**Addendum No. 01**

Subject: **Marin Classroom Modernization Project  
B-024C, B-025C of 2018/19**

Location : **Marin Elementary School  
3<sup>rd</sup> and Ontario Streets  
Philadelphia, PA 19140**

This Addendum, ***dated February 2<sup>nd</sup>, 2019***, shall modify and become part of the Contract Documents for the work of this project. Any items not mentioned herein, or affected by, shall be performed strictly in accordance with the original documents.

DRAWING NO.  
**A101**  
SHEET 07 OF 27

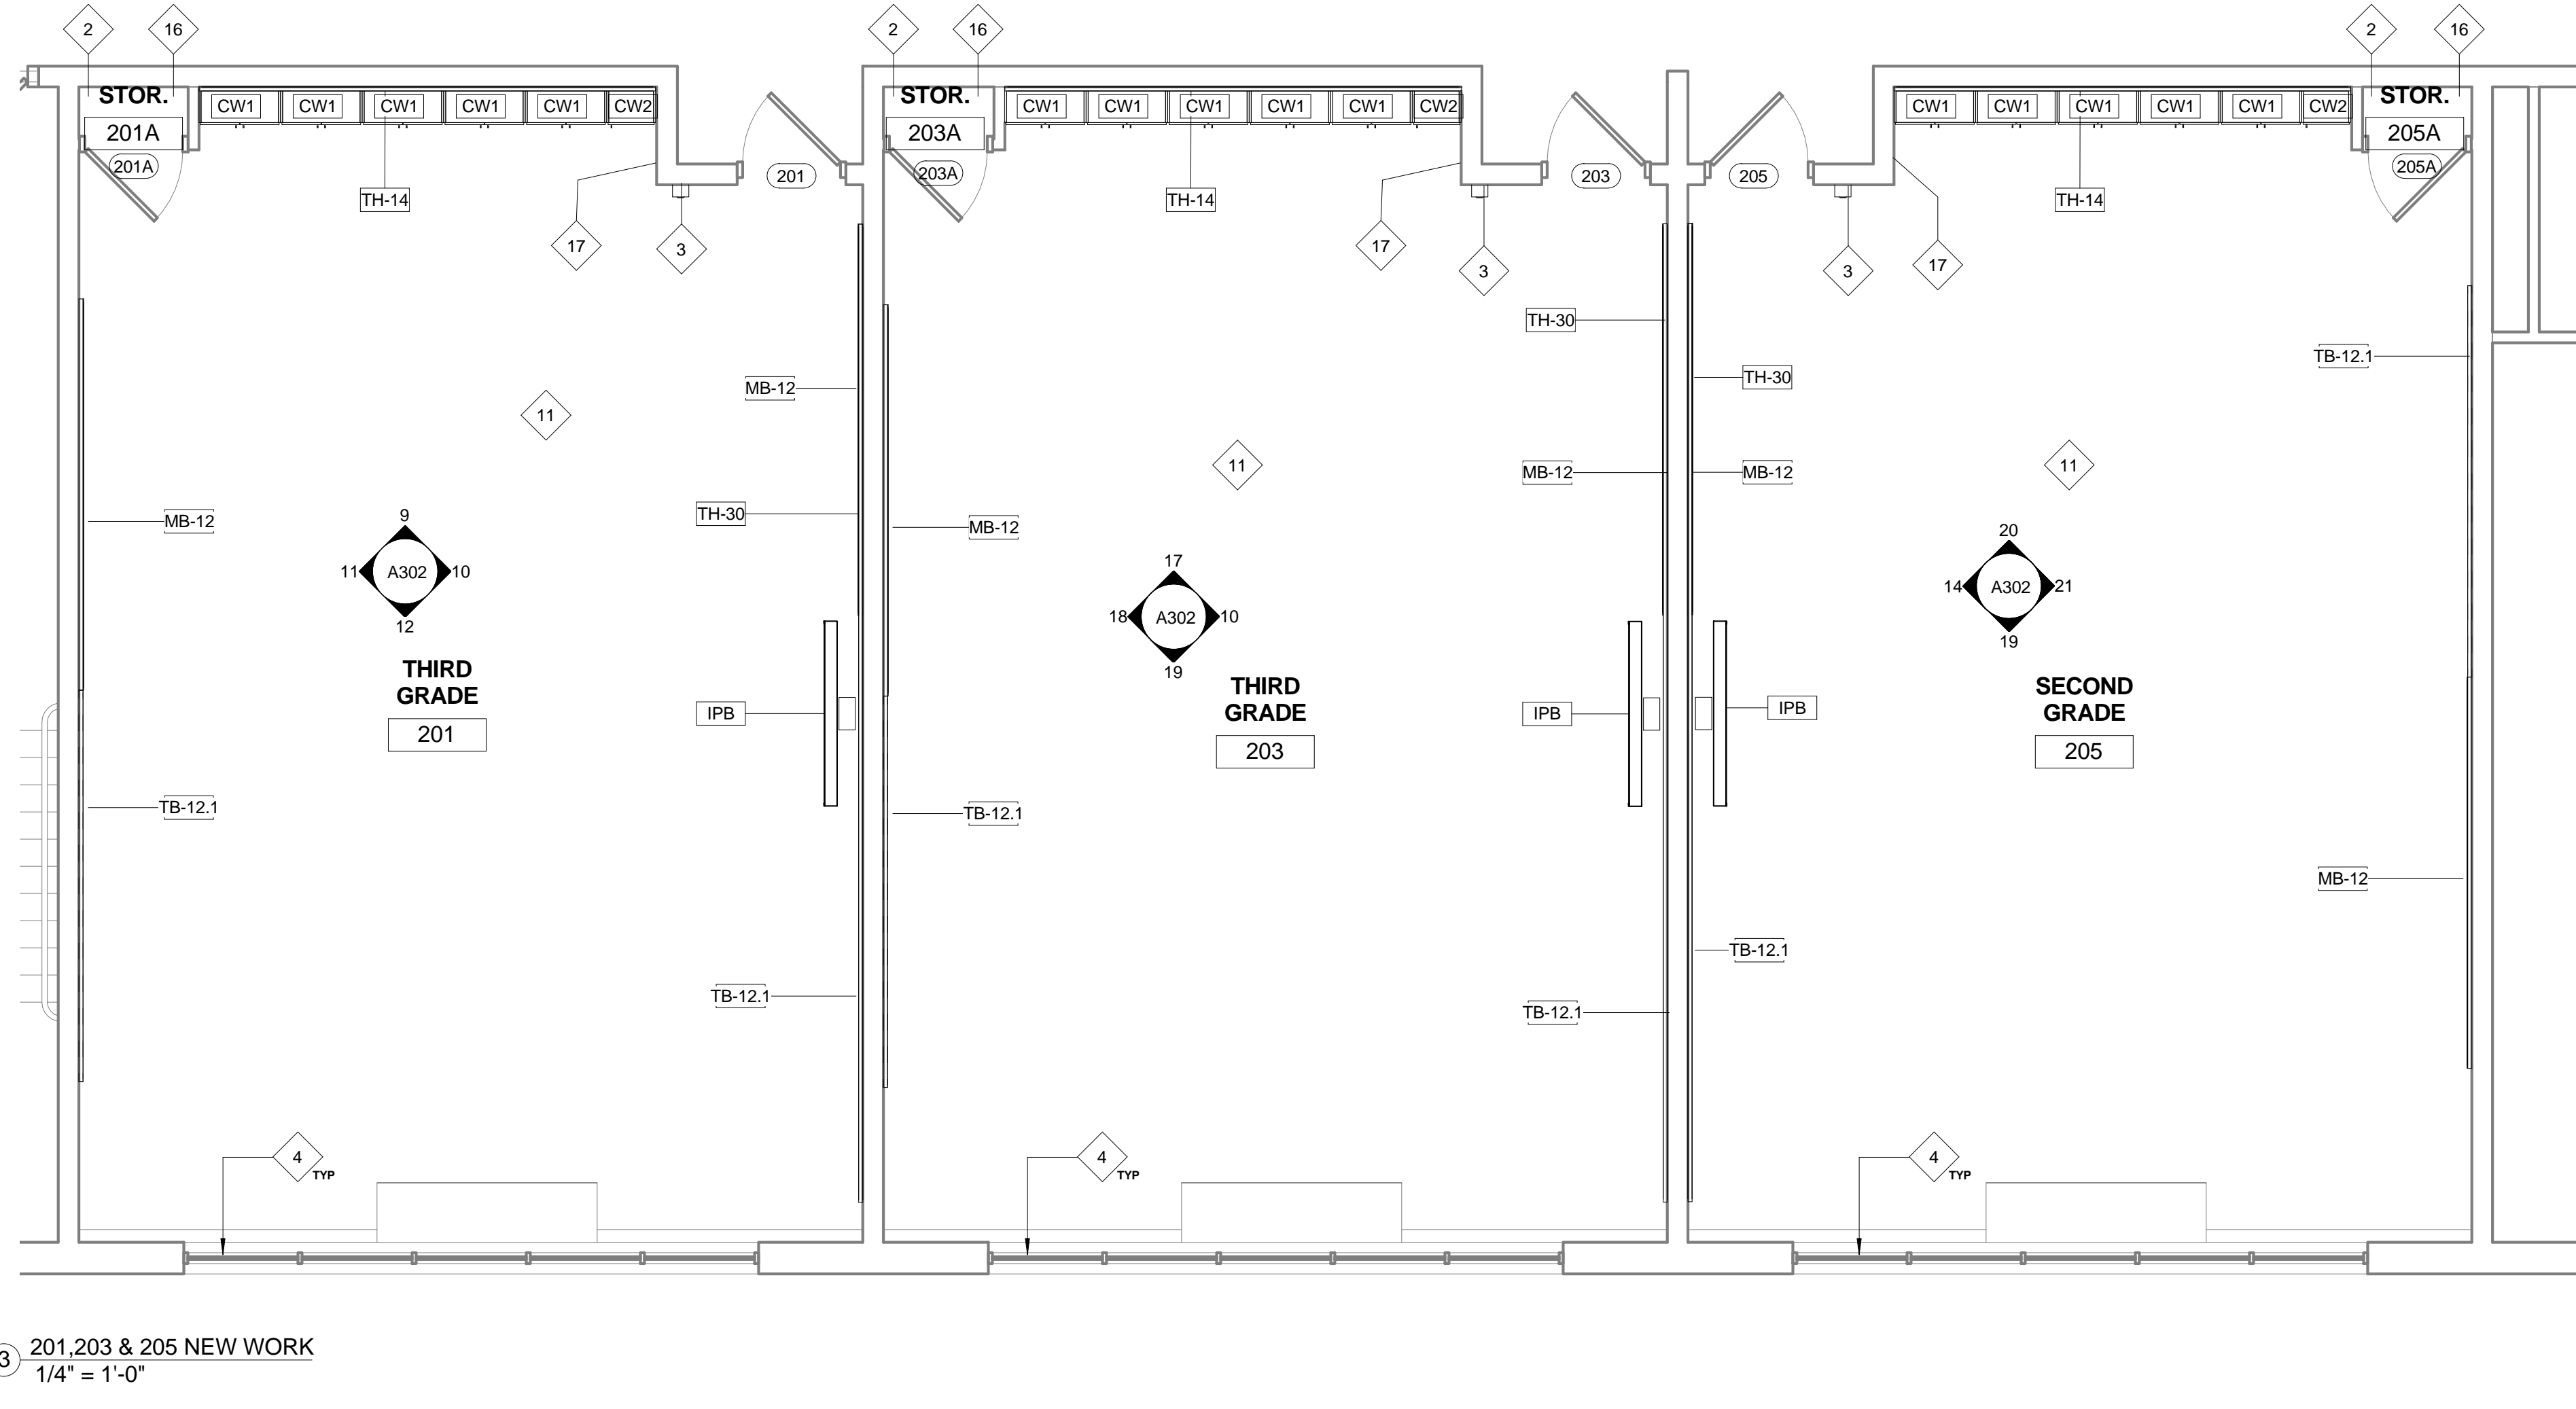
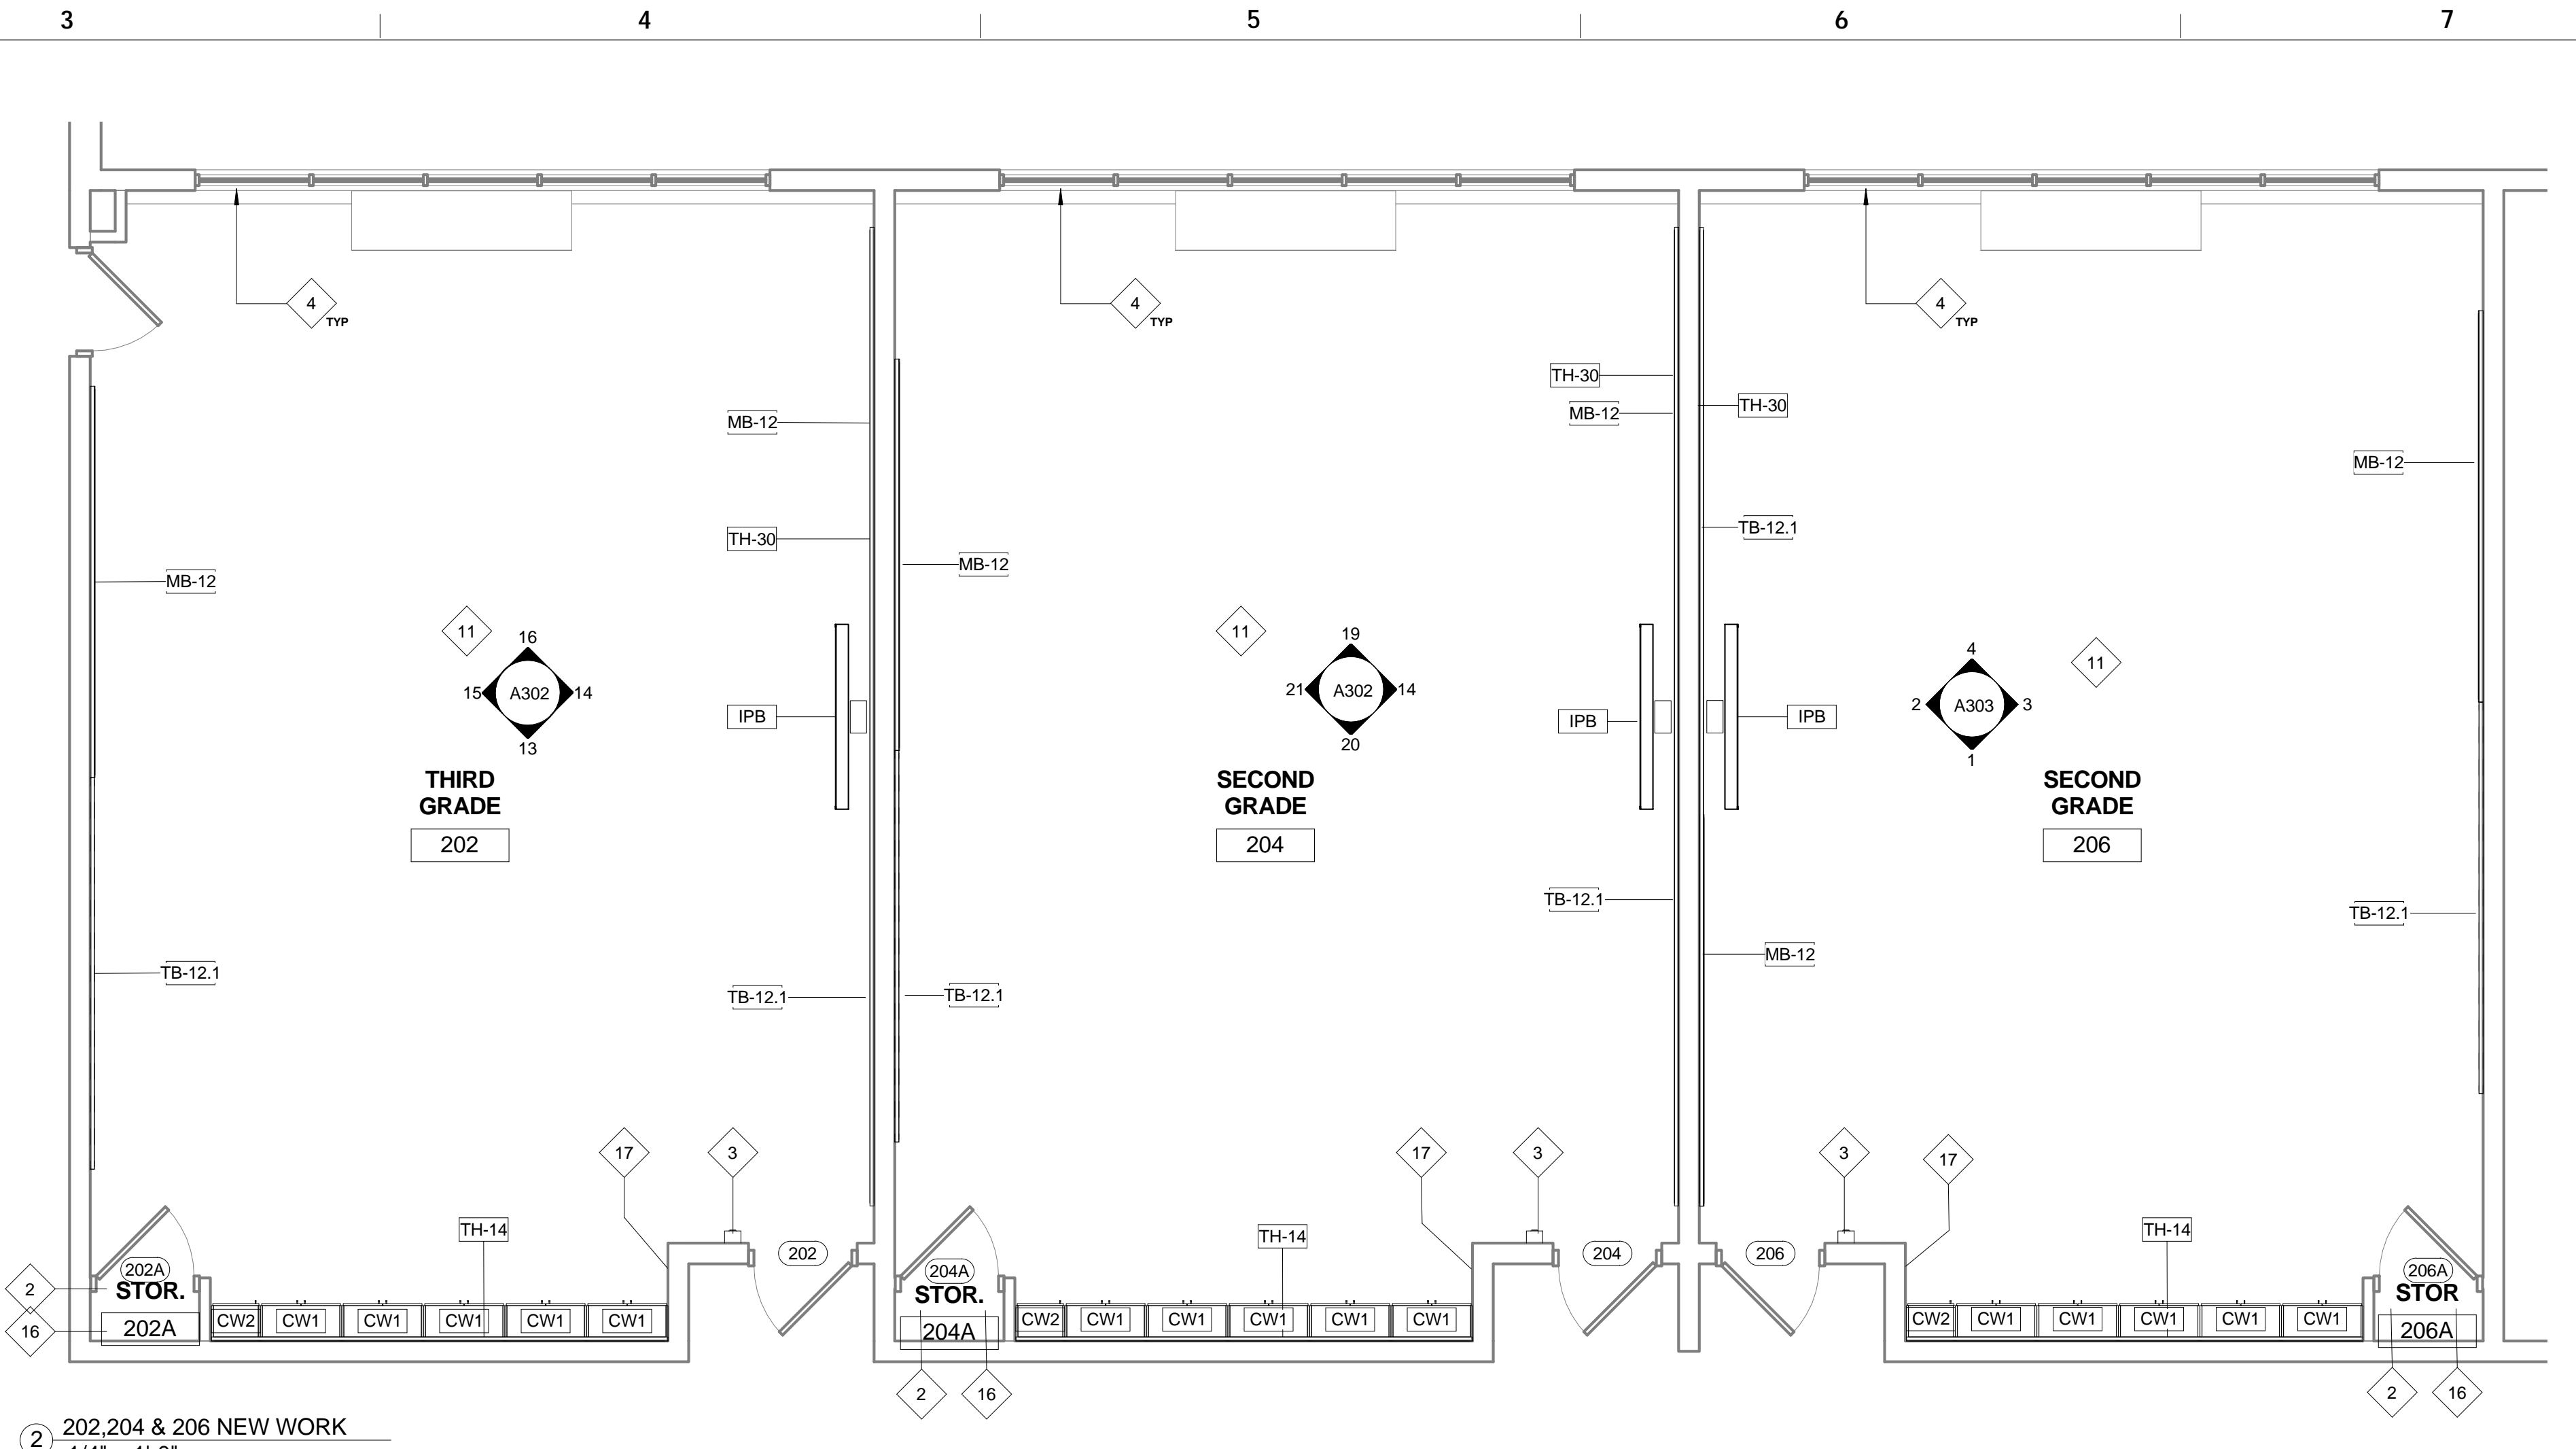
DETAIL 1 IS REVISED, SEE A101 REV 1 ISSUED WITH THIS ADDENDUM.
